HUACHUCA CITY TOWN COUNCIL WORK SESSION MEETING

**Re: Comments to FEMA RiskMAP Preliminary Mapping: Cochise County, AZ for
Huachuca City**

The following are comments from Cochise County Engineering and Natural resources Department for the Town of Huachuca City:

Huachuca, Babocomari River

Figure 1: Babocomari drainage area at state Hwy 90, per ArcMap, 61 subbasins, indicate 211.48 s.m.

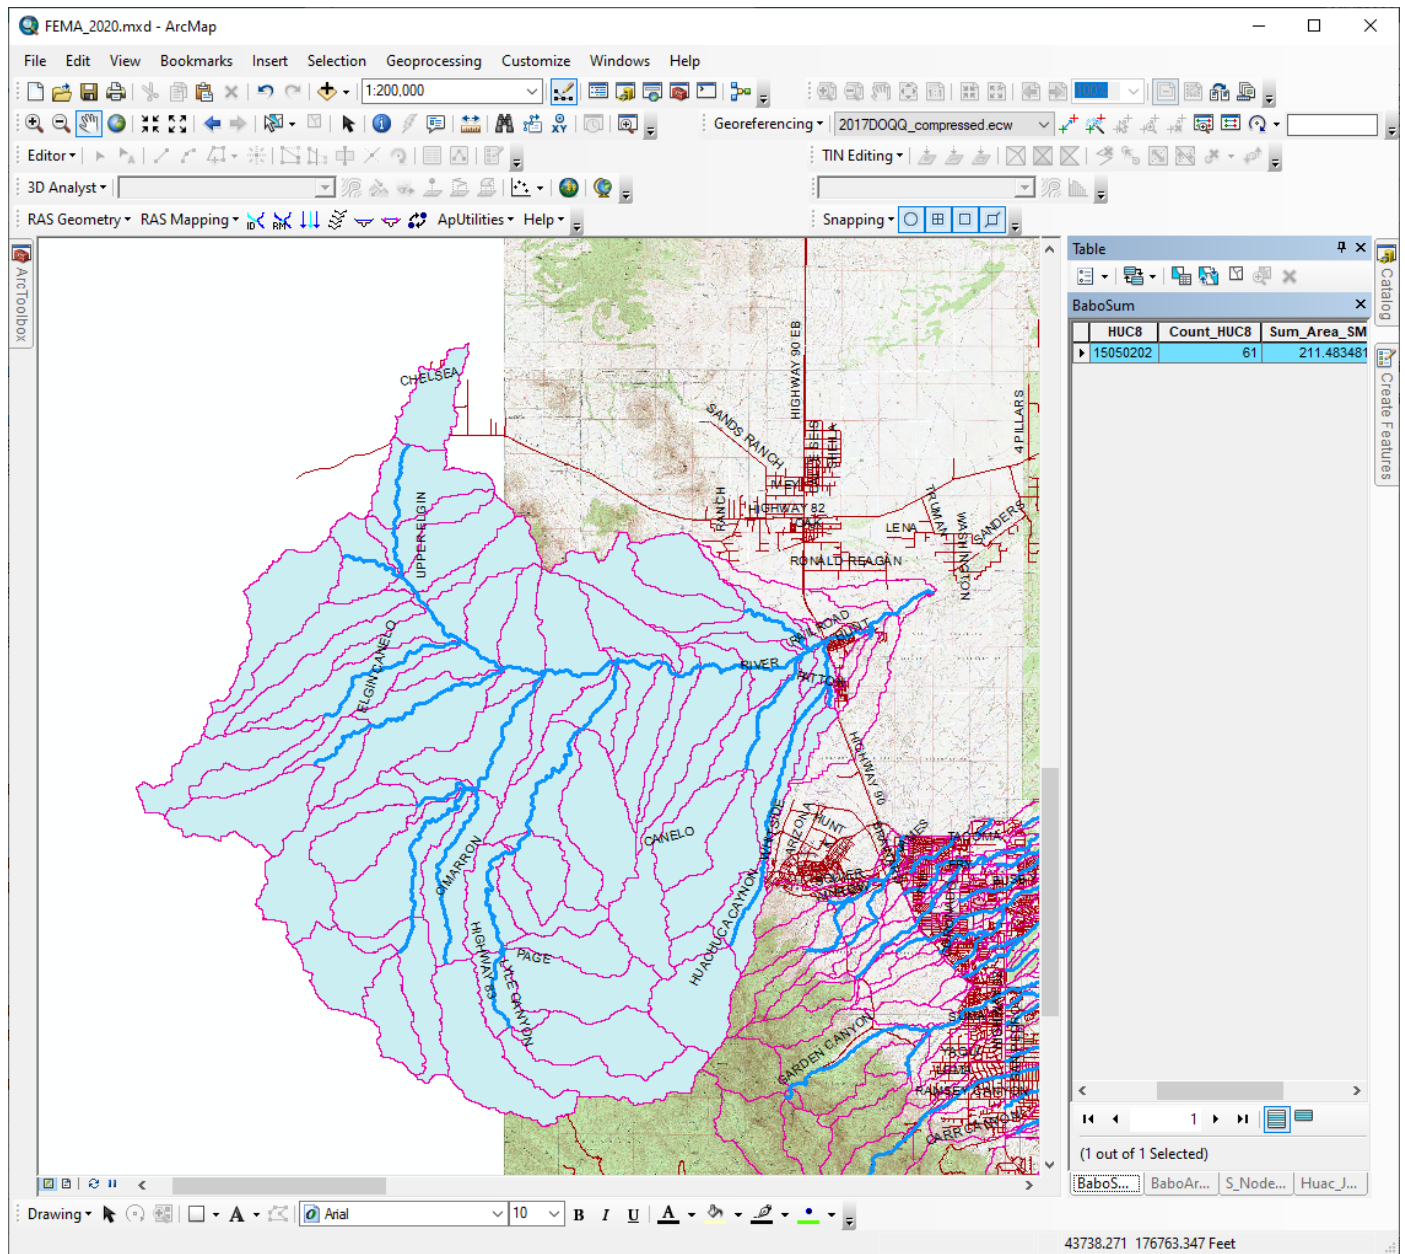
- 2) Section 5.1 of the Huachuca City Hydrology report indicates a revised drainage area of 199.26 square miles (s.m.) and a revised discharge of 17,862 cubic feet per second (cfs) at state Hwy 90. This conflicts with the 61 subbasins shown on shapefile layer (S_Subbasins.shp) which totals 211.31 s.m. (See Figure 1 of this comment document). This corresponds to Junction 26 (Huac_Junction-26) of the HMS program file. The discharge at this junction indicates a drainage area of 211.48 and discharge of 18,045 cfs. The HMS summary table at J223 indicates an area of 199.26 s.m. but has a resultant 100-yr 24-hr discharge of 17,876 cfs. It appears that the Junction for the Babocomari, per the subbasin and node shapefiles, should be at Huac_Junction-26. Please verify drainage area and resultant discharge at the State Route 90.

Figure 3. Revised floodplain mapping

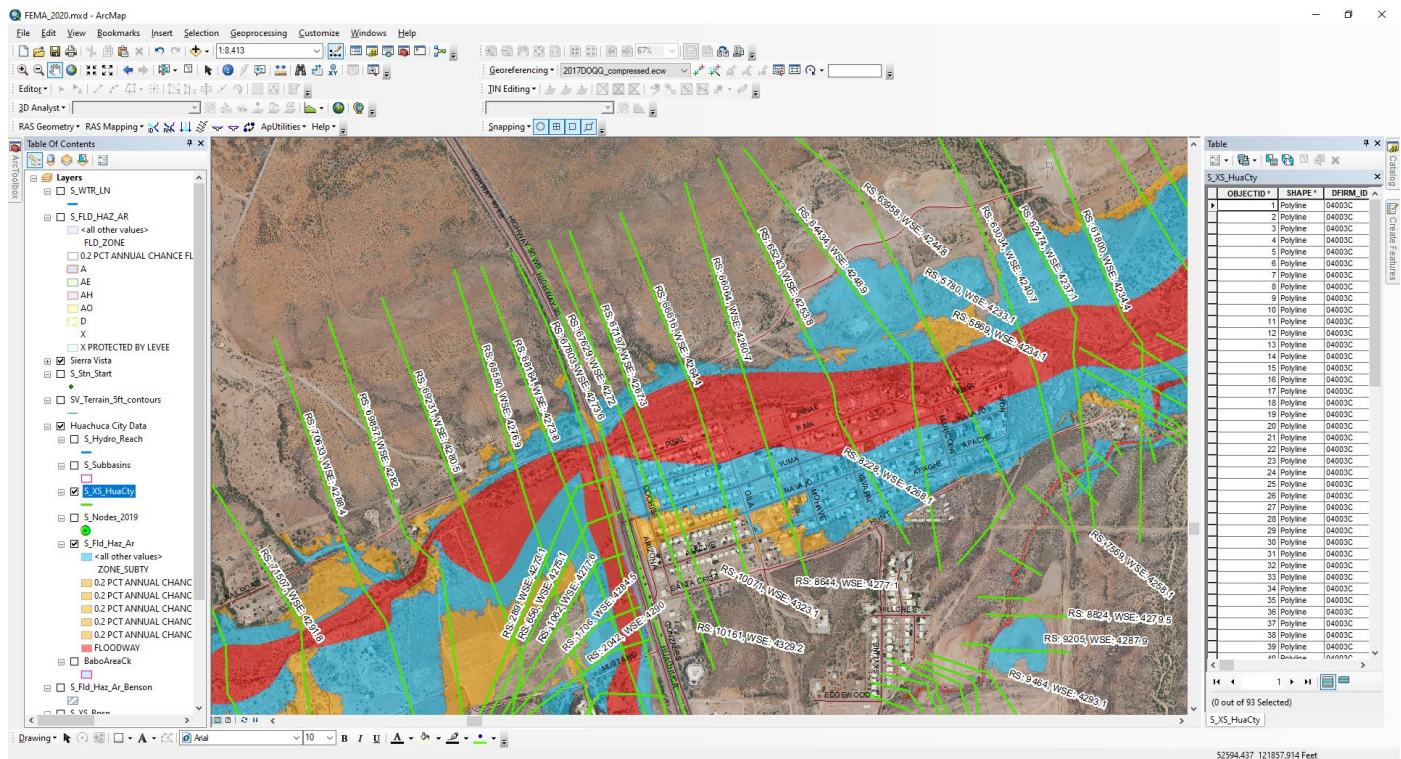
- 1) At River station (RS) 69857 (Water Surface Elevation [WSE] 4282), approximately 2,130 feet upstream of the bridge structure, the floodway is contained within the channel. Although the floodplain is reduced from the current effective mapping, how do both the floodplain and floodway widen as it approaches the bridge? With the channel widening (field visit) just downstream of RS 69857, the slope remaining consistent down to the bridge structure and an increase in incising of a channel (to RS , how do the floodplain and floodway increase with over 5,000 cfs of stormwater decrease? (See Figure 3 of this comment document).

Figure 4. Inconsistent water surface elevation values between HEC-RAS file and S_XS.shp file

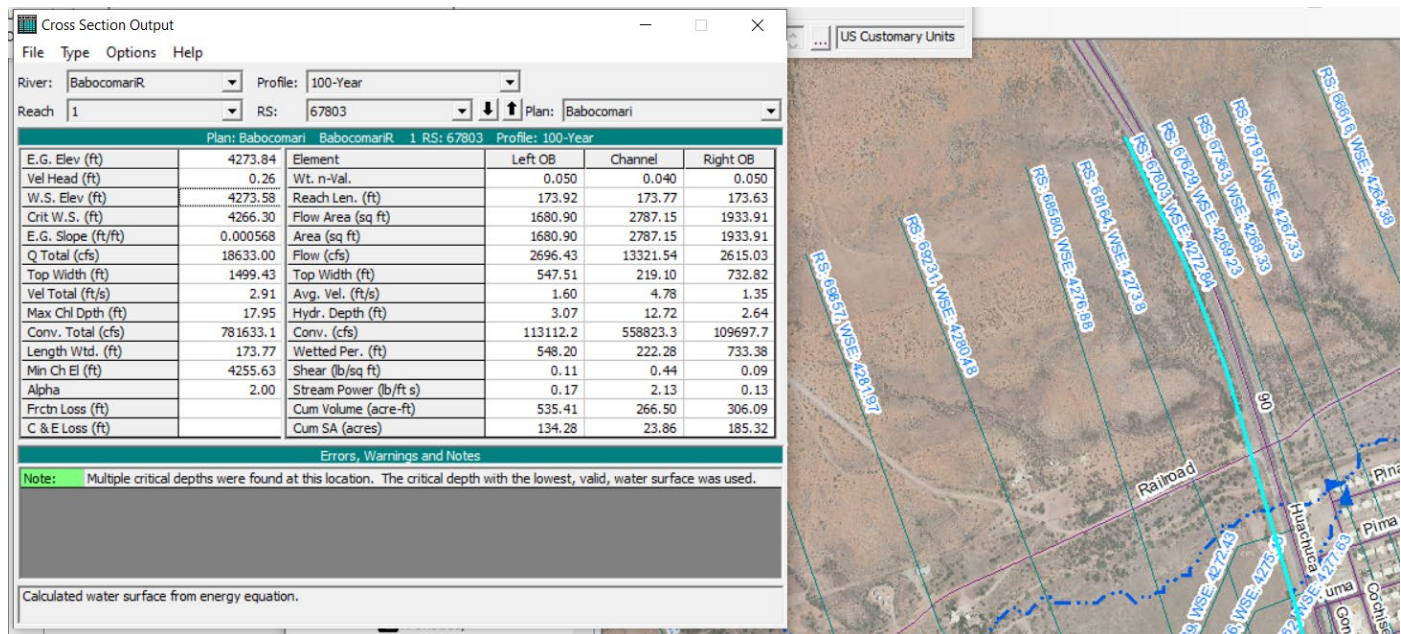
- 5) Please revise shape file S_XS.shp file to be consistent with HEC-RAS Model/ The WSE's are different (see Figure 4 of this comment document).
- 6) Why is a revised lower discharge with an incised channel from the effective mapping higher than the current value? The WSE at RS66064 per the revised HECRAS program (WSE=4260.71) is approximately 1.2 feet higher than an interpolated value of 4259.5 from the current FIS Data.
